Contract No. HY/2010/08
Central – Wan Chai Bypass – Tunnel (Slip Road 8 Section)
Submission of Additional Mitigation Plan for Slip Road 8 (Revision 7) under condition 2.16 of FEP-10/364/2009/B

**Central – Wan Chai Bypass Tunnel
(Slip Road Section 8)
Contract No. HY/2010/08**

Additional Mitigation Plan for Slip Road 8 under condition 2.16 of FEP- 10/364/2009/B

Revision: 7

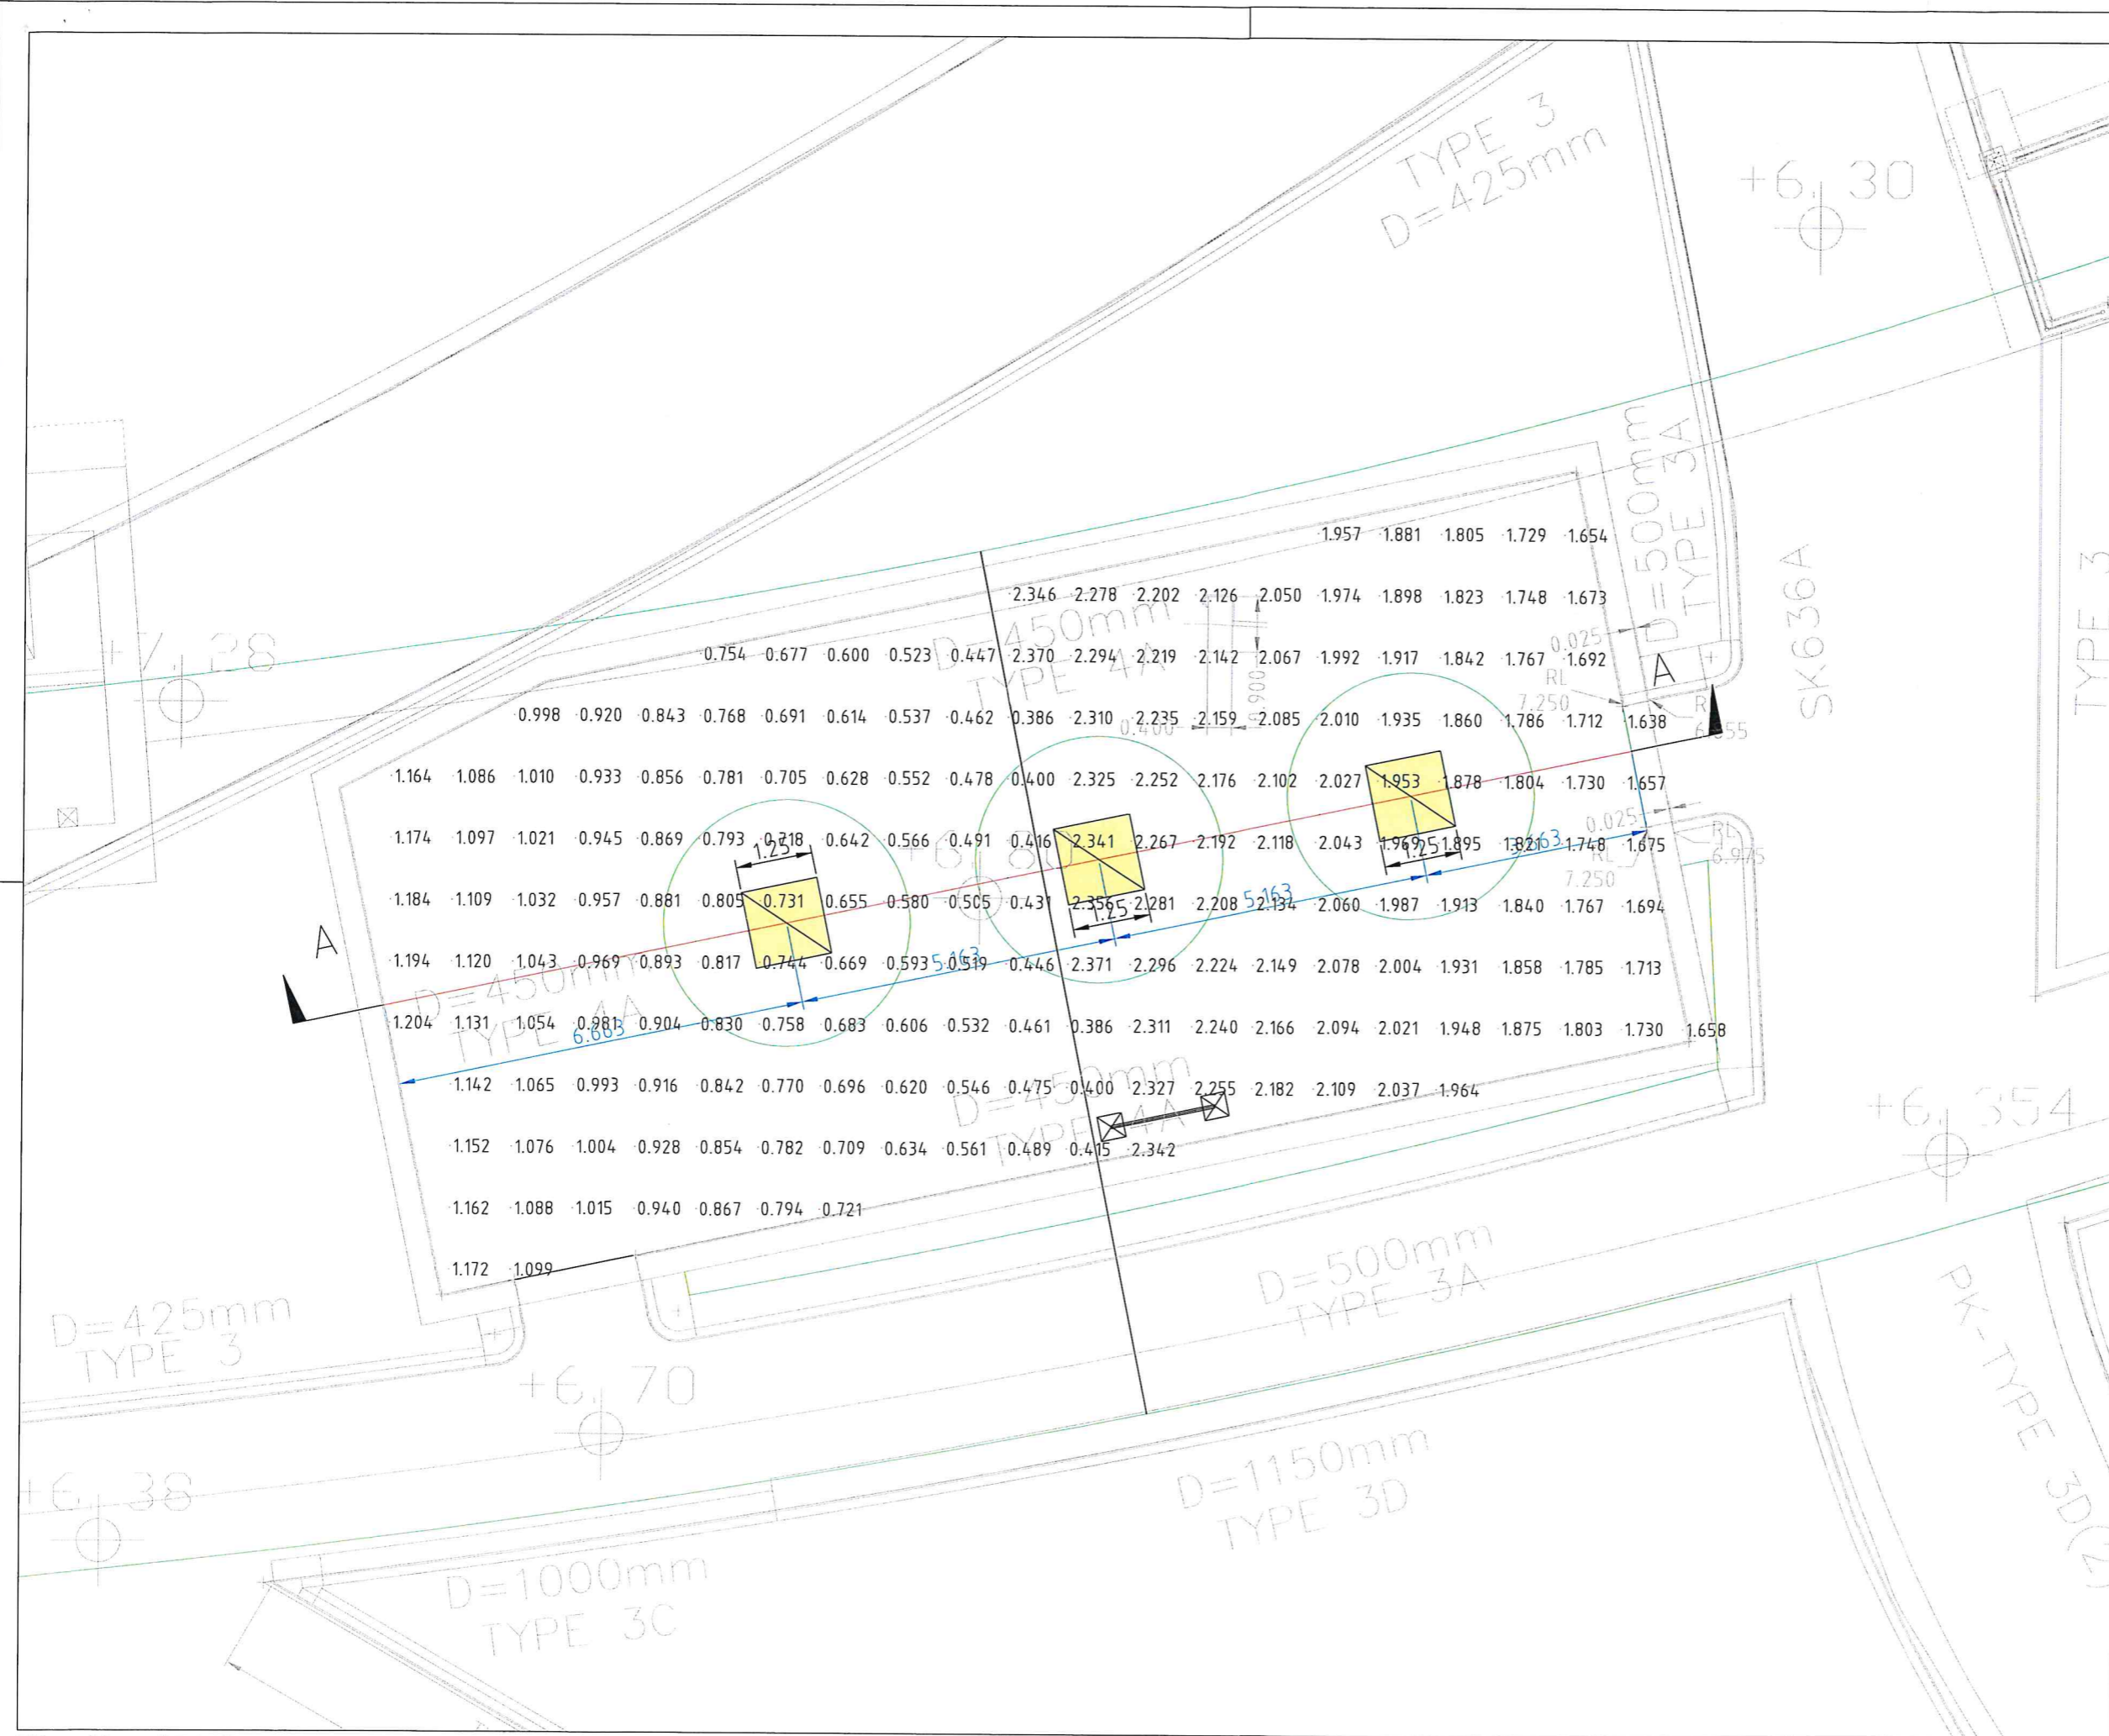
As checked and informed by the Contractor, there would be insufficient cover for installing the equipment due to structural feature below the Elderly Facilities area. We have to slightly shift the layout to suit. Please advise if you have any comment to the revised layout. Details are attached for your reference.

According to the site record, we found the design clearance of the elderly facilities at the middle area is not sufficient to install the proposed equipment. Therefore, we propose to shift the whole set of the equipment 1.5m toward east side. We also checked that the safety zone of the revised location is complied with LCSD's requirement (1830mm). Please assist us to seek for VPMO comment.

Original approved location plan with sectional view and new revised location plan are enclosed for your reference.

As confirmed by VPMO, we have no objection to the revised layout of elderly fitness facilities.

We have no comment for the revised location of elderly facilities.

SKETCH NO. 60095653/T2/SK0720 SCALE 1:500(A3)

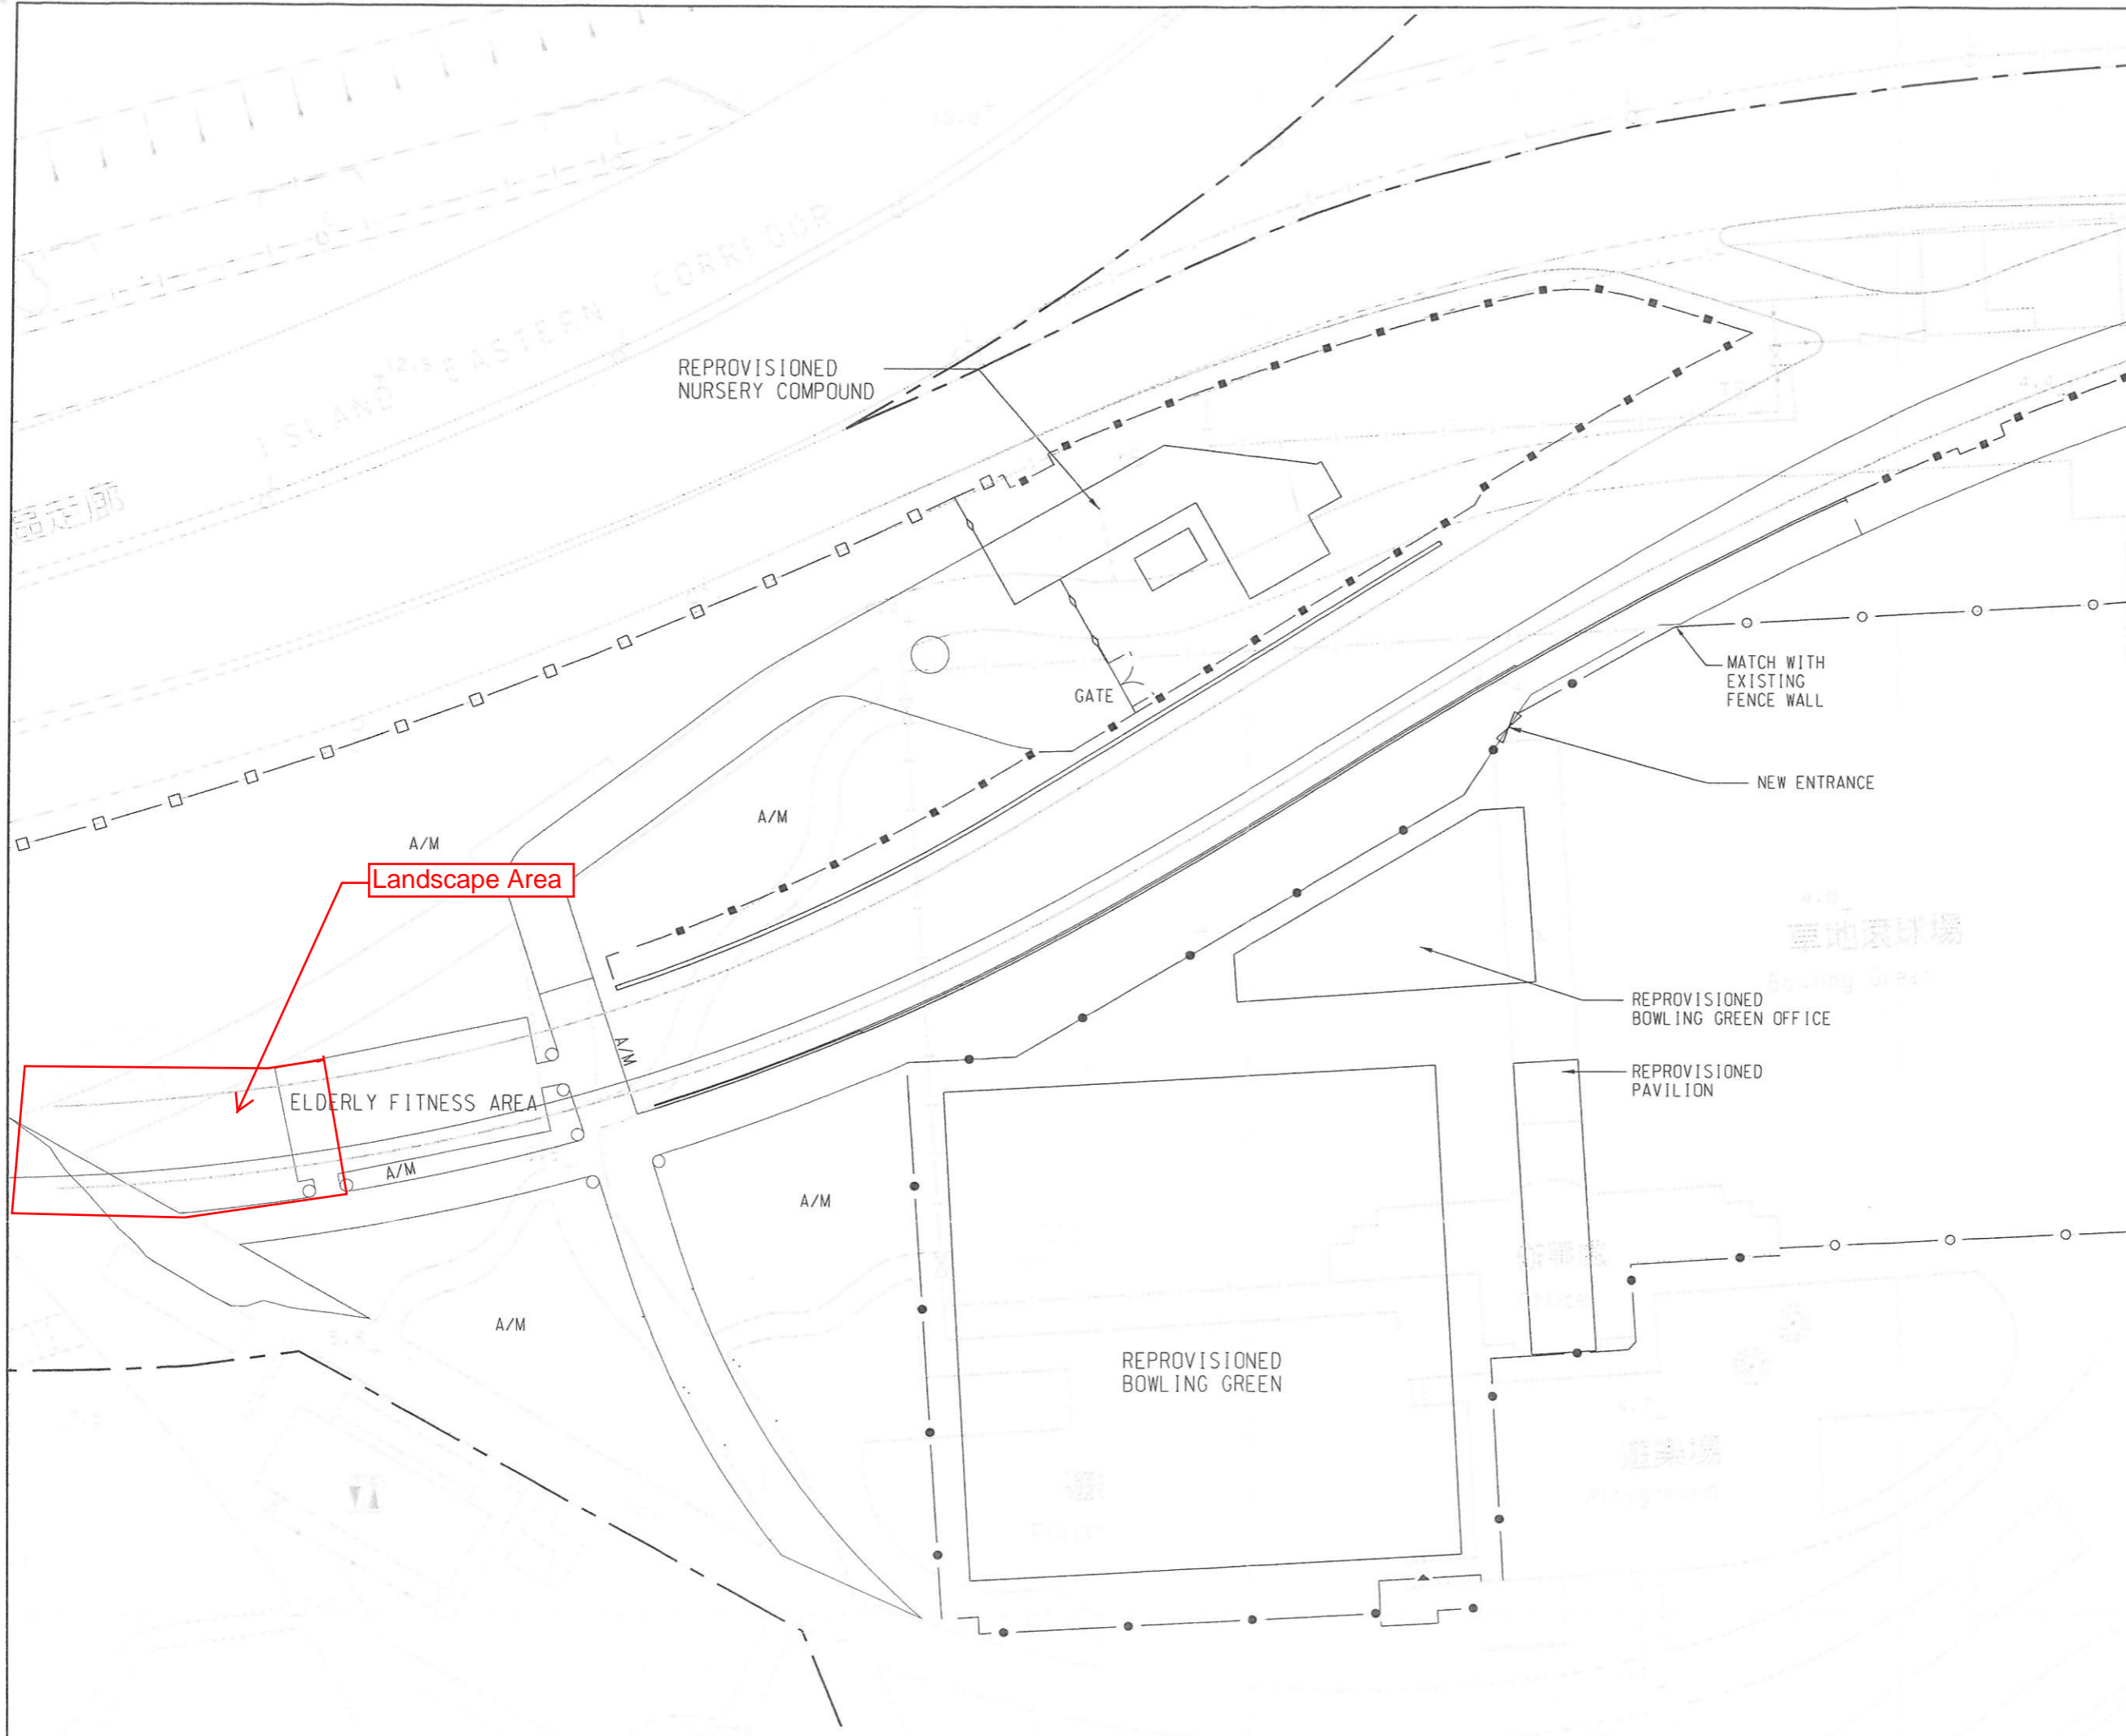
Contract No. HY/2010/08
Central-Wan Chai Bypass – Tunnel (Slip Road 8 Section)**Variation Order No. V/039**
Additional Elderly Fitness Facilities within Victoria Park

1. Supply similar to the attached photographs and install three sets (maximum) elderly fitness equipment as discussed and recorded in Victoria Park Working Group Meeting No. 47 in the "Elderly Fitness Area" as shown on the attached Sketch No. 60095653/T2/SK0720. The exact details and location of the elderly fitness equipment shall be confirmed and agreed on site with the ER.
